Product Code Change

Signal Relays

No. 2019006BE(ON)

Surface-mounting Relay G6S series Information of Product Code Change according to country origin change.

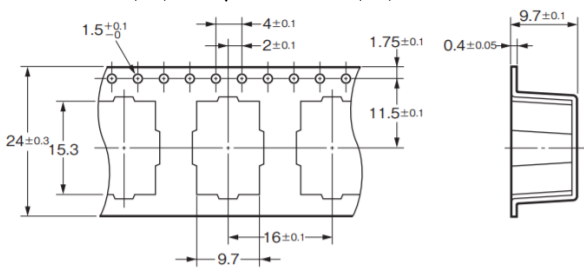
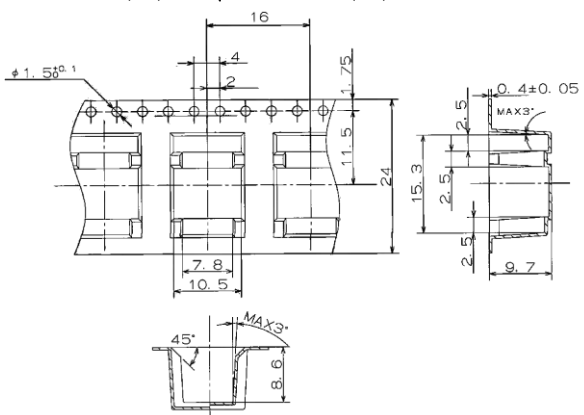
Before the change	After the change
<p>1. The country of origin. MADE IN JAPAN</p> <p>2. Indication of Relay Case Marking. MADE IN JAPAN Product Lot No. ****YH (****:Production date YH: Production factory code)</p> <p>ex.G6S-2F 12VDC</p>	<p>1. The country of origin. MADE IN CHINA</p> <p>2. Indication of Relay Case Marking. MADE IN CHINA Product Lot No. ****C□ □:1 or 2 (****:Production date C□: Production factory code)</p> <p>ex.G6S-2F 12VDC</p>
<p>3. Indication of the Packing label MADE IN JAPAN</p>	<p>3. Indication of the Packing label MADE IN CHINA</p>

Before the change	After the change
<p>4. Packing Tape packing 4.1 Dimension of carrier tape G6S-2F(-Y)-TR, G6SU-2F(-Y)-TR</p>  <p>Technical drawing showing top and side views of a carrier tape. Dimensions include: 1.5±0.1, 4±0.1, 2±0.1, 1.75±0.1, 9.7±0.1, 0.4±0.05, 24±0.3, 15.3, 11.5±0.1, 16±0.1, and 9.7.</p> <p>4.2 Color of carrier tape Color: Black</p> <p>4.3 Packing box and external box</p> <p>Packing box Dimension: Approx. 332 x 332 x 60(mm) Material: Coat board</p> <p>External box Dimension: Approx. 370 x 350 x 390(mm) Material: Card board Qty.: 4000 pcs. (Packing box 5pcs.)</p> <p>Tube packing</p> <p>Packing box Dimension: Approx. 800 x 365 x 110(mm)</p>	<p>4. Packing Tape packing 4.1 Dimension of carrier tape G6S-2F(-Y)-TR, G6SU-2F(-Y)-TR</p>  <p>Technical drawing showing top and side views of a carrier tape. Dimensions include: 16, 4, 2, 1.75, 11.5, 24, 15.3, 2.5, 2.5, 9.7, 0.4±0.05, 7.8, 10.5, 1.55±0.1, 45°, 8.6, and MAX3°.</p> <p>*No change the width and pitch of tape</p> <p>4.2 Color of carrier tape Color: Transparent</p> <p>4.3 Packing box and external box</p> <p>Packing box Dimension: Approx. 350 x 350 x 90(mm) Material: Coat board</p> <p>External box Dimension: Approx. 420 x 380 x 390(mm) Material: Card board Qty.: 3200 pcs. (Packing box 4pcs.)</p> <p>Tube packing</p> <p>Packing box Dimension: Approx. 800 x 290 x 110(mm)</p>
